PRELIMINARY SAFETY ANALYSIS REPORT AND DESIGN REVIEW OF THE 2 KW(e) RADIOISOTOPE THERMOELFCTRIC GENERATOR

MAI-127

Contract N00025-74-C-0020

FIGURE 3.2

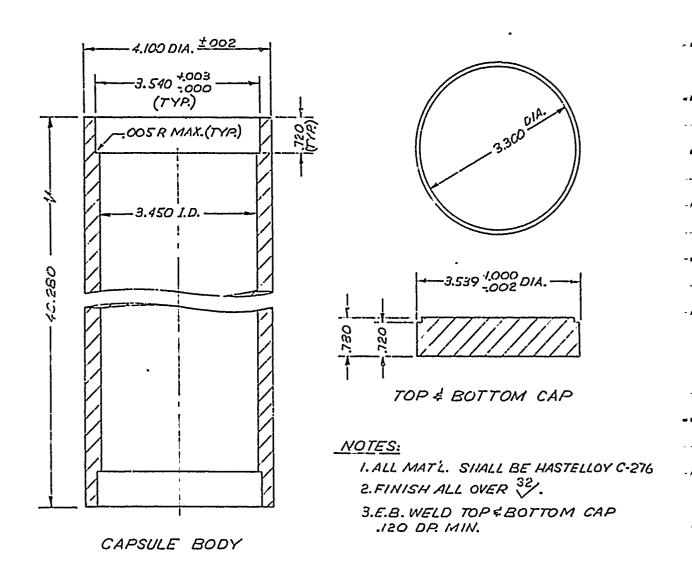
The plasma arc weld used to seal the capsules proved inadequate during the impact test conducted for this program. An electron beam weld has been recommended in Ref. 1. It is recommended that this welding technique be subject to impact testing before a design change is specified.

Figure 5.2 Hypothetical Small Seawater Leak

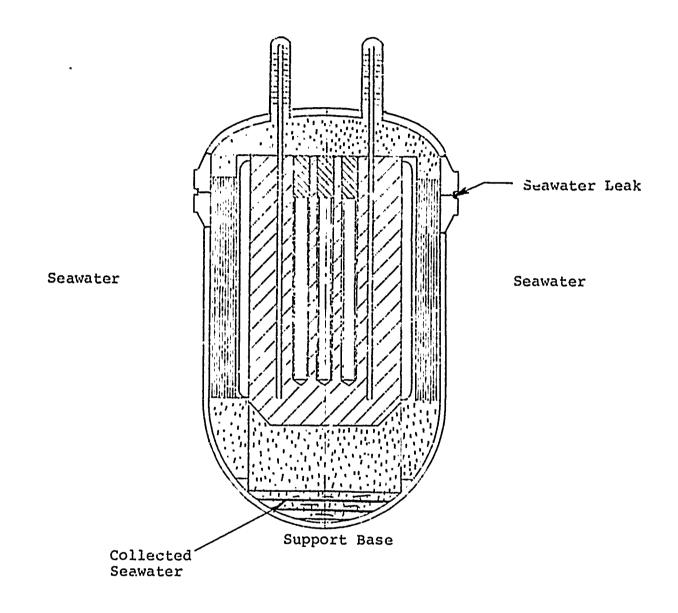
In Figure 5.2 the reference RTG is shown with a hypothetical leak in the pressure vessel seal. The seawater jets in, but cannot strike any surface above boiling temperature and thus remains liquid, accumulating in the bottom pressure vessel and impregnating the non-fusible insulation. Eventually the water depth may become great enough that it boils and forms steam.

The available internal volume for steam to occupy, assuming an effective pressure vessel height of 73.6 inches and an internal diameter of 50 inches is 1.45×10^5 cubic inches.

FIGURE A.2

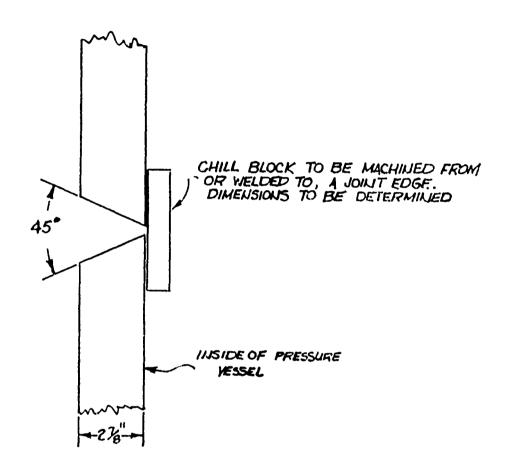
This comparison assumes a configuration for the Weld joint as shown in Figure A.2. The bolted closure is shown in Figure A.3. The bolted closure includes a flat elastomer Oring seal at the range contact surfaces. This material assumption is consistent with the probable selection of BUNA-N for the Oring. It is recognized that the Oring configuration selected for the final design will represent the experience and preference of the designer. Double Oring systems with a groove cut for the outside ring, or grooves for both rings are a possibility. The purpose of the designs of Figures A.2 and A.3 is to provide a base point for the comparison that is consistent with good engineering practices. It is recognized that they may be modified by the final designer.

A welded final closure will require a chill block that is either machined or welded to the interior of one of the edges (see Figure A.1).

A bolted joint is recommended over a welded joint. A hybrid joing, utilizing holts to provide structural rigidity and a seal weld to provide leak tightness offers advantages and is recommended for further study.
